To: T10 Technical Committee
 From: Rob Elliott, HP (elliott@hp.com)
 Date: 8 June 2007
 Subject: 07-268r0 SAM-4 Protocol services as UML operations

Suggested changes

Figure 14 — SCSI Domain class diagram overview [\[modified - removed AC Task, Task Set, Task\]](#)

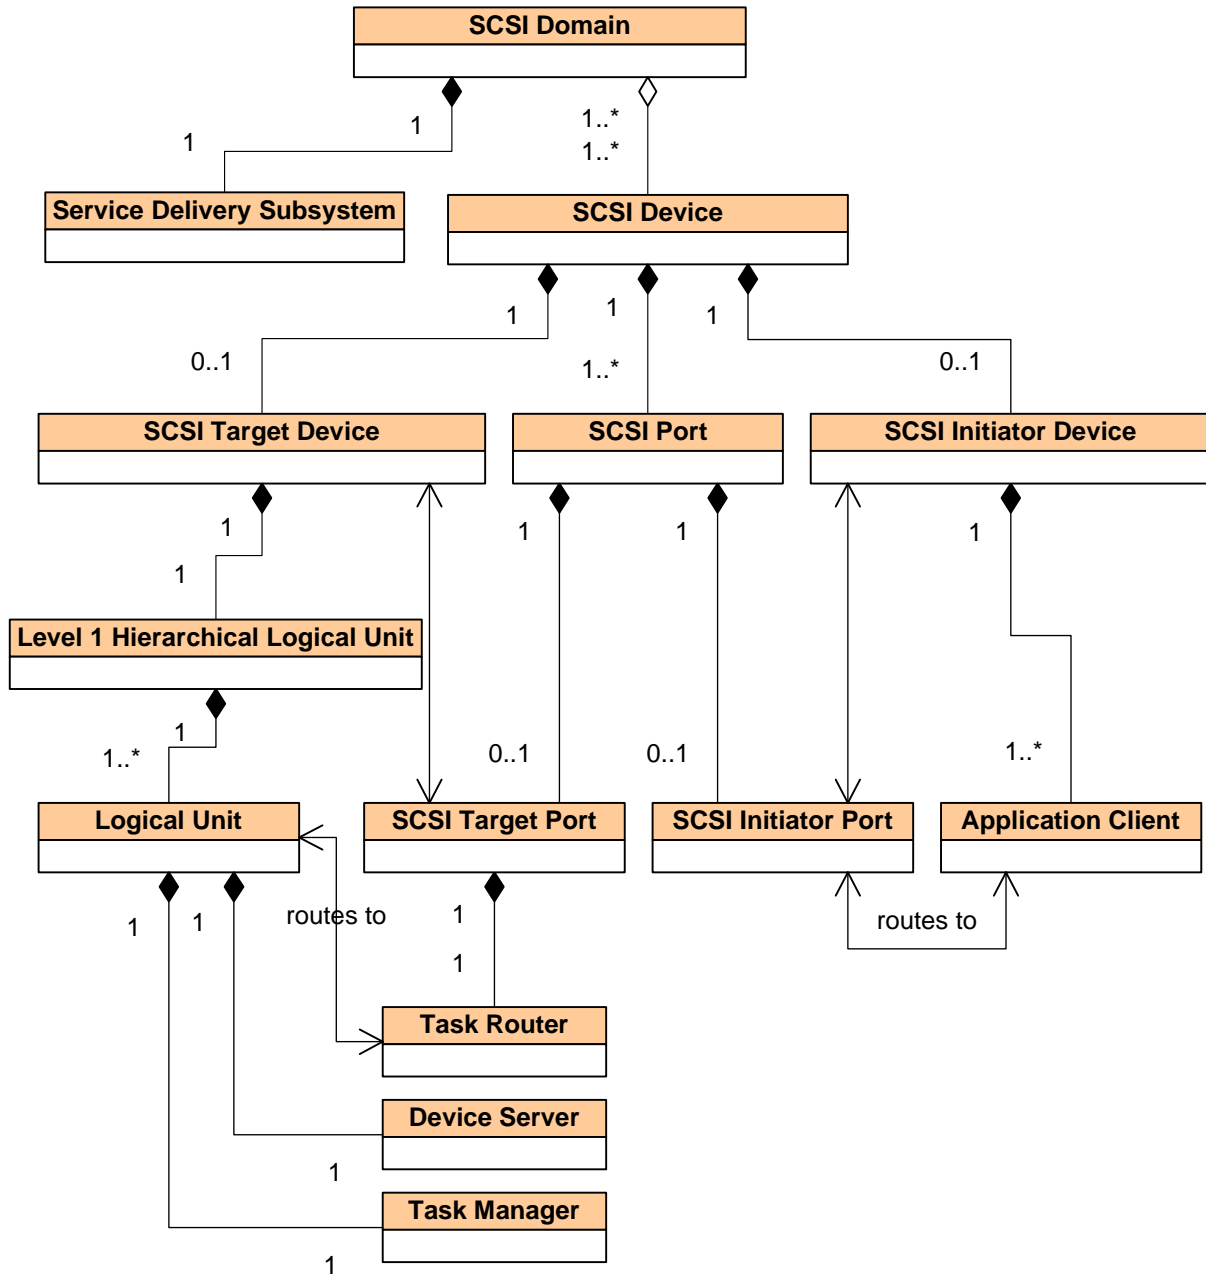
2. On the initiator side, changes are made to the task-related objects to parallel the structure of tasks/task sets on the target side:

- a) Task -> Application Client Task
- b) Task Management Function -> Application Client Task Management Function
- c) Application Client Task removed
- d) Application Client Task Set - contains 0 or more Application Client Tasks

This avoids having two classes with the same name (Task) but with different meaning to an initiator and target.

Figure 18 — SCSI Port class diagram [\[based 07-263 and modified mainly to add operations\]](#)

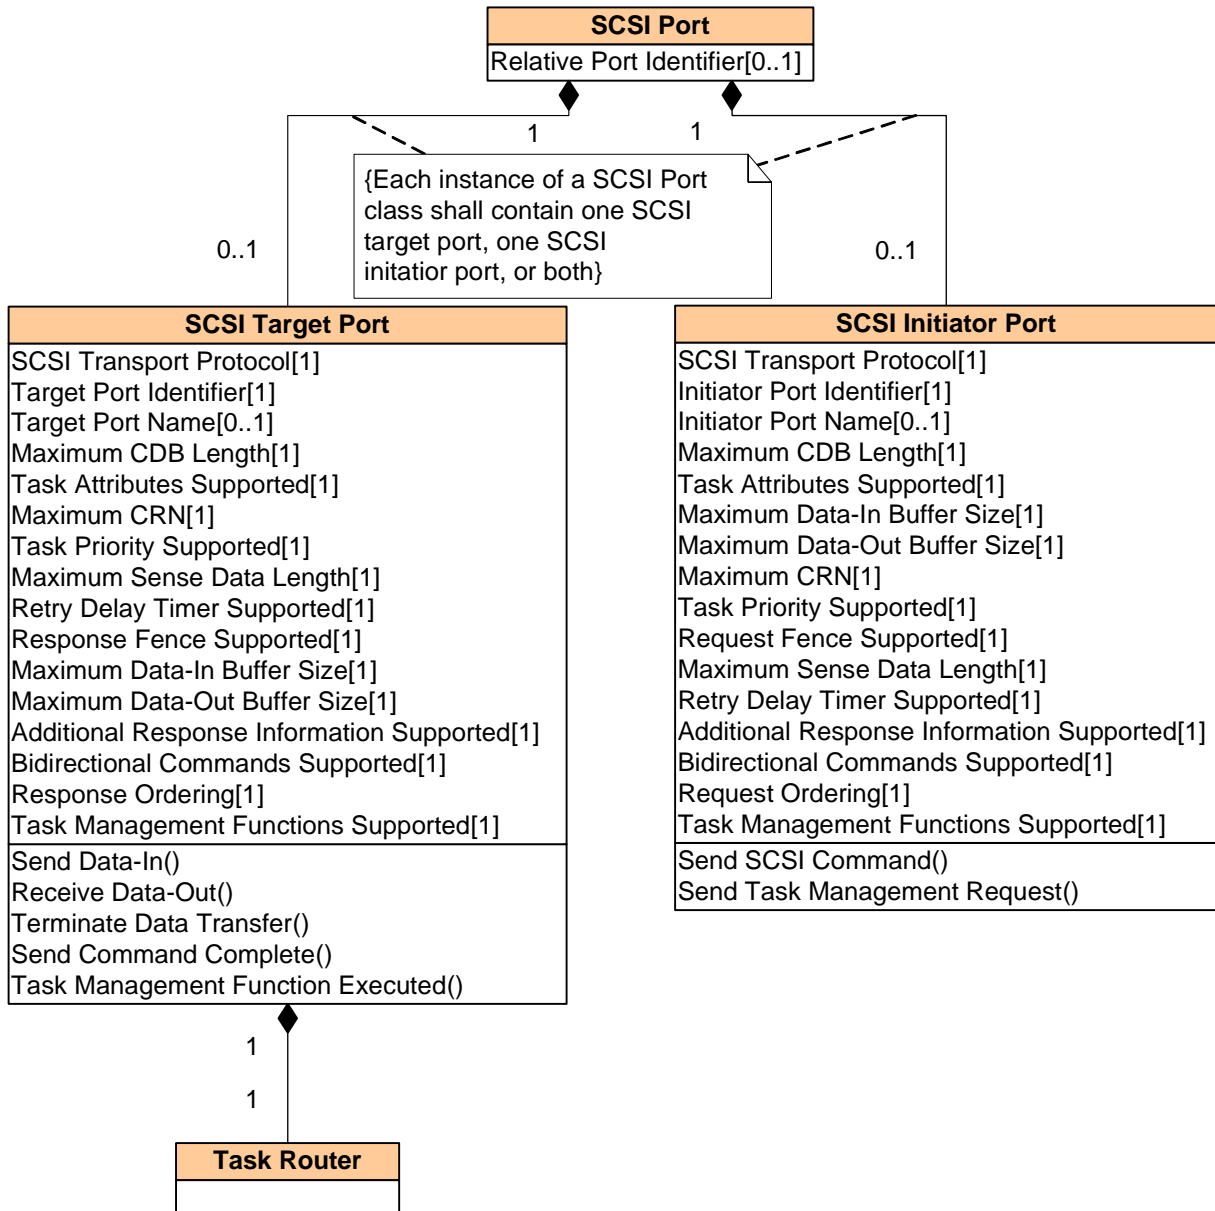
[Editor's Note 8: Reason: rewording in terms of objects rather than instances.](#)

[Objects in the SCSI Target Port class invoke the following operations:](#)

- a) [Device Server class SCSI Command Received \(\) operation \(see 4.5.20.2\); and](#)
- b) [Task Manager class Task Management Request Received \(\) operation \(see 4.5.21.1\).](#)

[Each object in the SCSI Port class contains:](#)

- [a\) one SCSI Target Port object \(see 4.5.6\) that contains:

- \[A\\) one Task Router object \\(see 4.5.8\\);\]\(#\)](#)
- [b\) one SCSI Initiator Port object \(see 4.5.7\); or](#)
- [c\) both.](#)

Figure 19 — SCSI Initiator Device class diagram [modified]

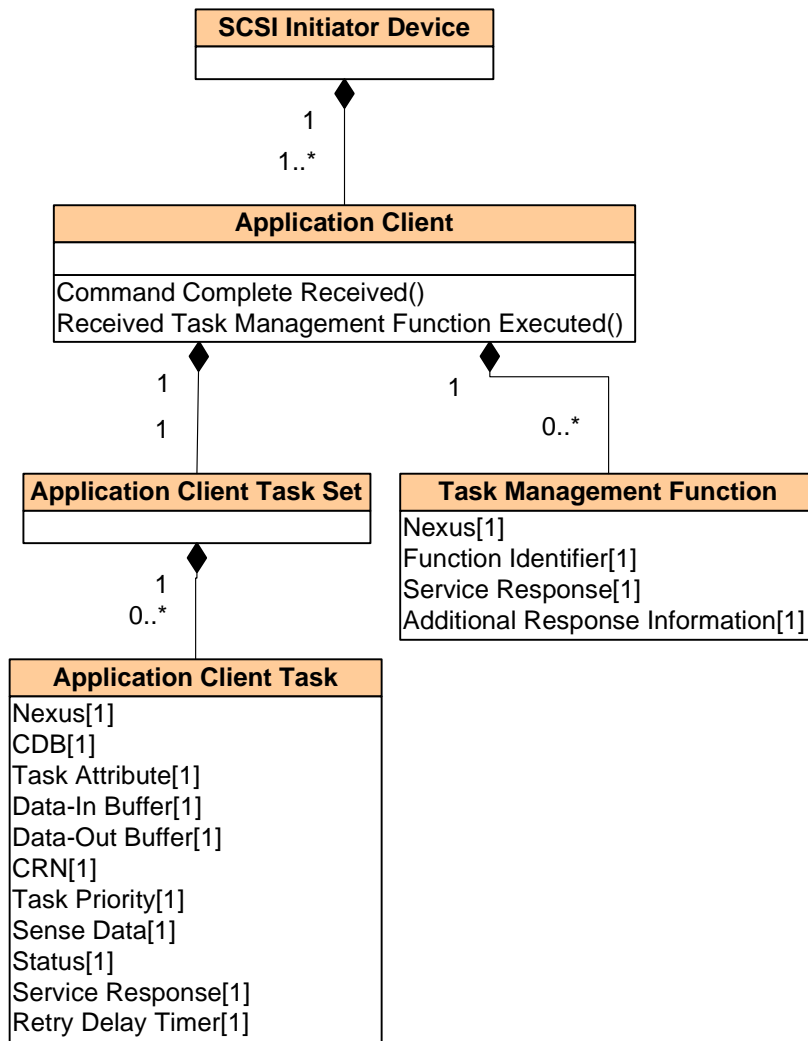
Editor's Note 4: Reason: That was about the only use of "application client task", hardly deserving of keeping the term around. Changing "application client task" to mean a task as known on the initiator side (parallel to "task" on the target side).

The SCSI Initiator Device class (see figure 19) contains the:

- a) Application Client class (see 4.5.10) that contains the:
 - A) Application Client Task Set class (see 4.5.11) that contains the Application Client Task class (see 4.5.13); and
 - B) Application Client Task Management Function class (see 4.5.14).

Figure 22 — Logical Unit class diagram [\[modified\]](#)

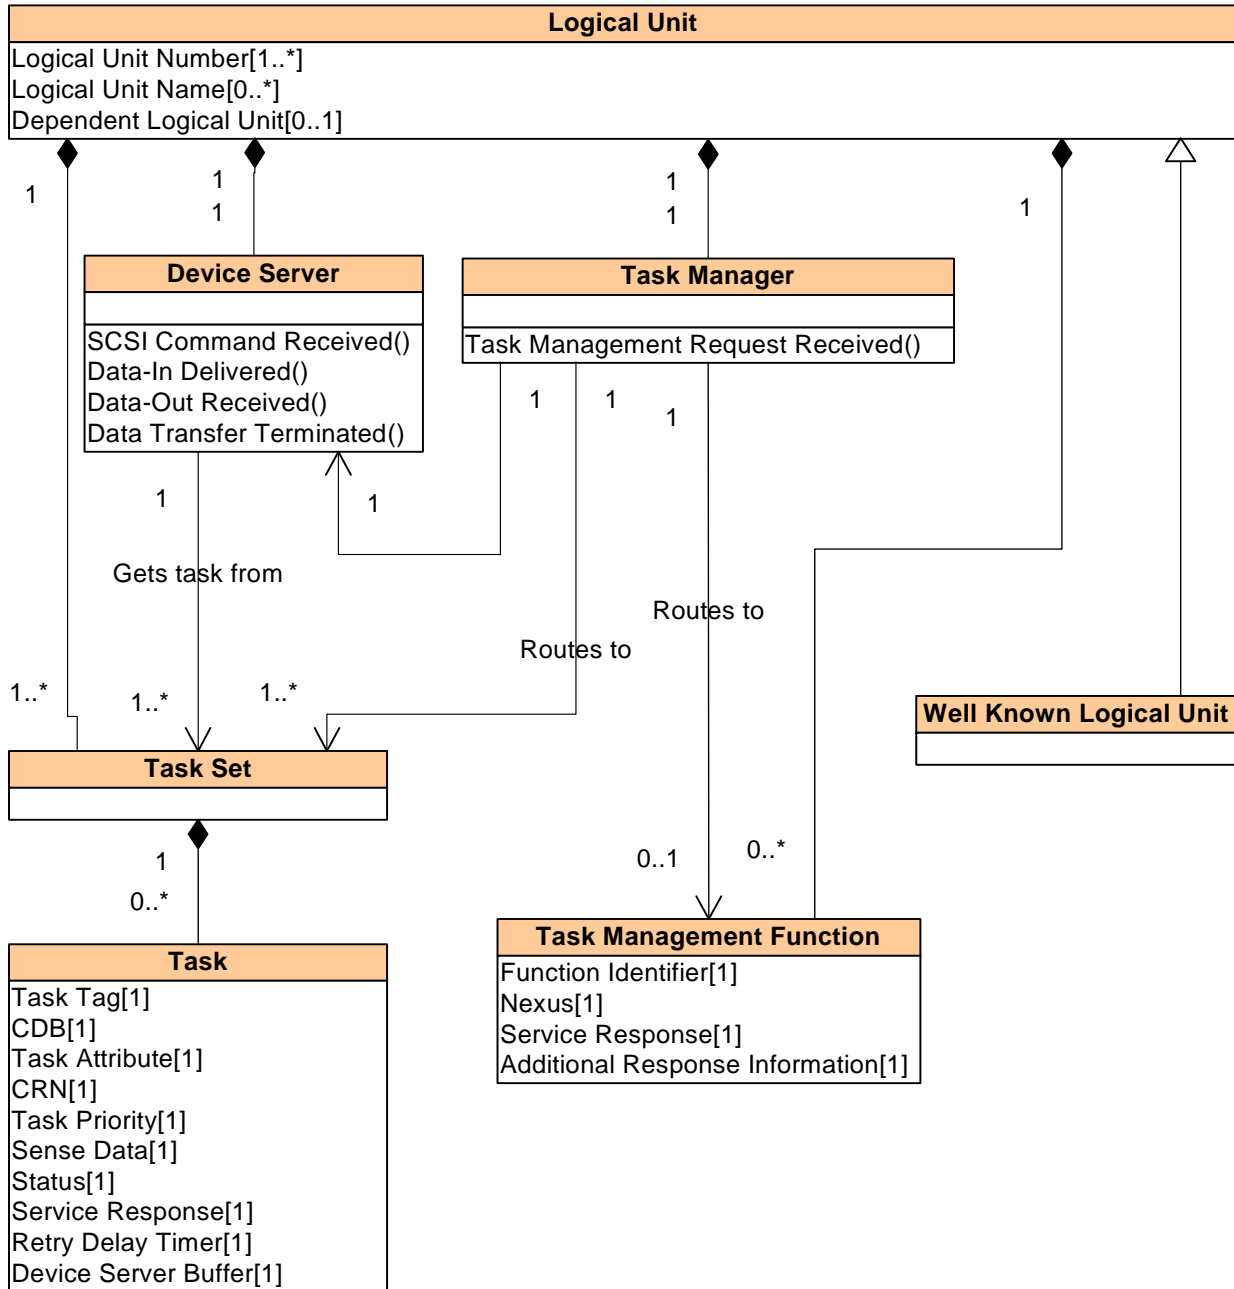
~~A~~The Logical Unit class (see figure 22) may be substituted with the:

- a) Well Known Logical Unit class (see 4.5.19.1); or
- b) Level 1 Hierarchical Logical Unit class, Level 2 Hierarchical Logical Unit class, Level 3 Hierarchical Logical Unit class, or Level 4 Hierarchical Logical Unit class.
